Airstream Service Bulletin

Bulletin Number: #186

Product Line: Airstream Atlas, Interstate 19, Interstate 24 with Lithium Batteries

**Subject: Magnum 1000W Inverter/Charger Settings, Cable Inspection and Fuse Replacement,
Diode Removal, & Victron Charger and Battery Minder Settings**

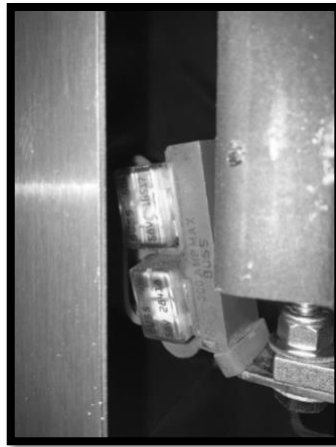
- Locate the CS battery and remove the cross-car cable from the positive battery post with the 90A fuse.
- Remove the 90A fuse and replace it with a 100A fuse. Reinstall the cross-car cable and torque the battery terminal nut to 75 inch-lbs.
- Locate the RS battery and remove the cross-car cable and cable #14 (cable #9 on Interstate 24's) from the positive battery post with the 90A fuse.
- Remove the 90A fuse and replace it with a 100A fuse. Reinstall the cross-car cable and cable #14 (cable #9 on Interstate 24's), and torque the battery terminal nut to 75 inch-lbs.
- Locate the cable from the DC-DC converter, going up towards the driver's seat, and ensure it is connected to the 50A fuse in the fuse block, located under the driver's seat.

NOTE: the 100A fuse must be closer to the battery terminal than the 50A fuse since it is of a higher rating.

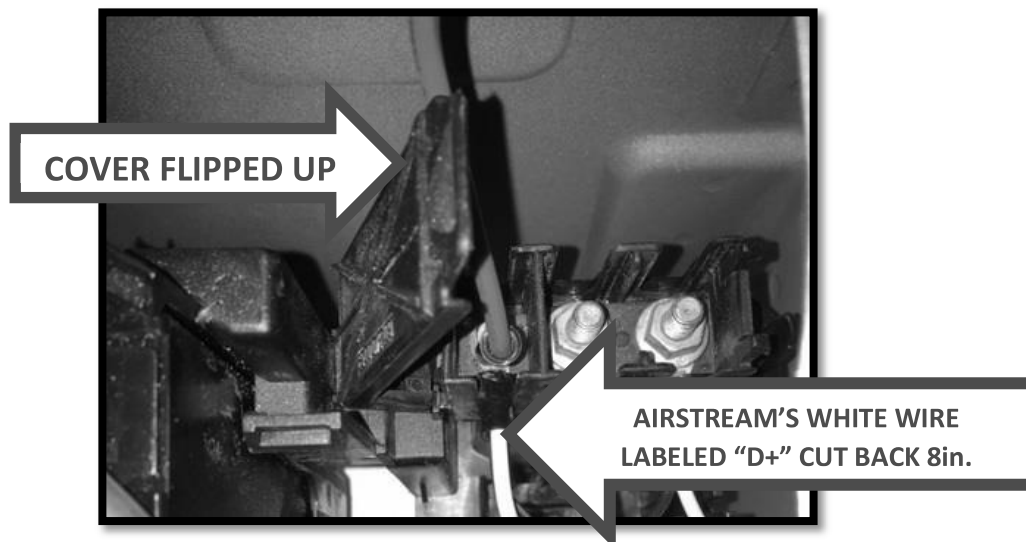
The Location of the Engine Running Terminal, purple wire, and the DC-DC mounting plate screws are shown in the picture below. Remove the DC-DC mounting plate screws to access the terminal block. The Engine Running Terminal, and two other terminals are located, on this block, under the flip up cover in the location shown below. The smallest, and closest to the front of the vehicle, is the Engine Running Terminal.

Next, locate the white "D+" wire and cut it about 8" from the terminal. Cap the wire that comes from the harness using a 14 AWG butt splice. Use electrical tape over the capped end to protect the cap and store the wire in the seat compartment. The other end that is connected to the terminal will need connected in the next step.

From the DC-DC convertor, locate the purple wire exiting from underneath the cover. Follow the purple wire back until it changes to white and goes into a heat shrunk resistor. Cut the white wire on the other side of the heat shrink. Use a 14 AWG butt splice to cap the wire that comes from the harness. Use electrical tape over the capped end to protect the cap and store the wire in the seat compartment. Next, connect the purple+white heat shrunk wire to the white “D+” wire left connected to the Engine Running Terminal, using a 14 AWG butt splice.

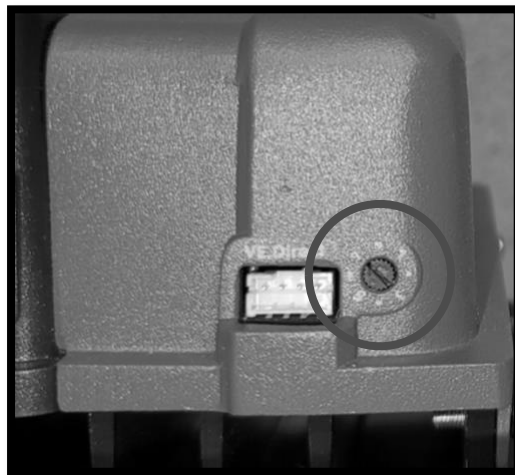
2. On Interstate 24's, the solar controller is behind the display in the overhead compartment, behind the driver's seat. You will need to remove 4, Phillips-head screws, holding the panel of displays in place (shown in the image below).

To verify the settings, make sure the arrow in the dial is pointed at “7.” This will ensure the proper setting for the Lithium batteries. A small, flat-head screwdriver will be needed to turn the dial. Once completed, the solar controller can be put back in place, and the corresponding compartments put back together.
